DART AEROSPACE LTD	Work Order: 143643
Description: Crosstube Assembly (AS350/355 High Aft SS)	Part Number: D350-748-243
Inspection Dwg: D350-748-243 Rev: A	Page 1 of 2

DART AEROSPACE LTD HAWKESBURY, ONTARIO, CANADA	
DRAWING NO. D350-748-243	REV. A SHEET 1 OF 4
TITLE CROSSTUBE (AS 350/355 HI AFT)	SCALE NTS
COPYRIGHT © 2015 BY DART AEROSPACE LTD THIS DOCUMENT IS PRIVATE AND CONFIDENTIAL AND IS SUPPLIED ON THE EXPRESS CONDITION THAT IT IS NOT TO BE USED FOR ANY PURPOSE OR COPIED OR REPRODUCED IN ANY FORM OR BY ANY MEANS WITHOUT WRITTEN PERMISSION FROM DART AEROSPACE LTD.

DRAWING NO. D350-748-243	TITLE CROSSTUBE	REV. A	DART AEROSPACE LTD ENGINEERING ORDER		D.E.O. NO. D350-748-243-A-1	SHEET NO. SHEET 1 OF 1	SCALE NTS
DRAWN <i>qp</i>	CHECKED <i>ASS</i>	MFG. APPR. <i>[Signature]</i>	APPROVED <i>[Signature]</i>		DE APPR. <i>[Signature]</i>		
DATE 15.11.18	DATE 15.11.18	DATE 16.02.19	DATE FEB 19 2016		DATE 2016.02.19

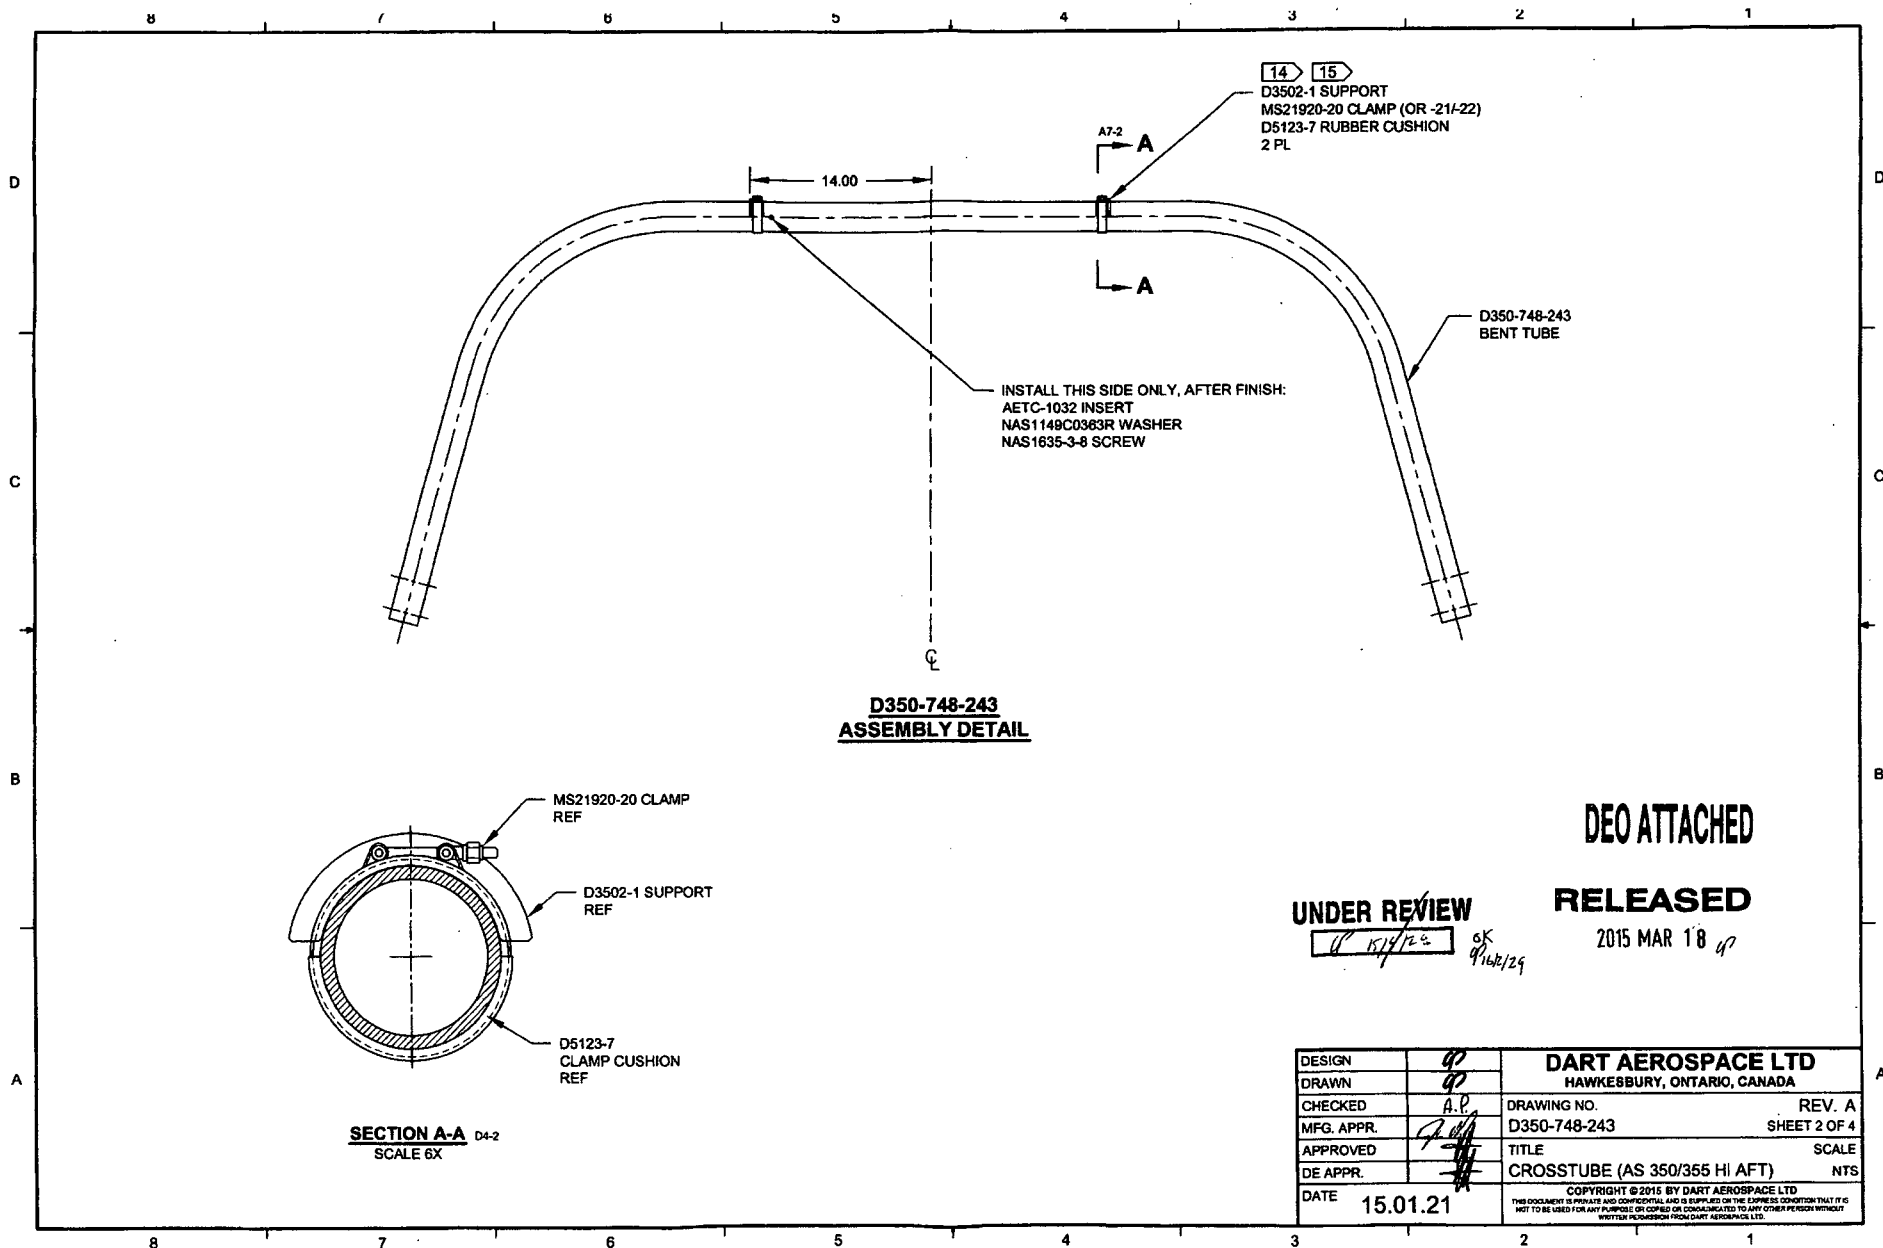
AMEND NOTE 2 (SHEET 1) AS FOLLOWS:

- 2) FINISH: PREPARE SURFACE PER DART QSI 005 4.1.4
 PRIME INSIDE AND OUTSIDE PER DART QSI 005 4.2
 PAINT OUTSIDE PER DART QSI 005 4.2
 OR
 POWDER COAT WHITE (4.3.5.2) PER DART QSI 005 4.3
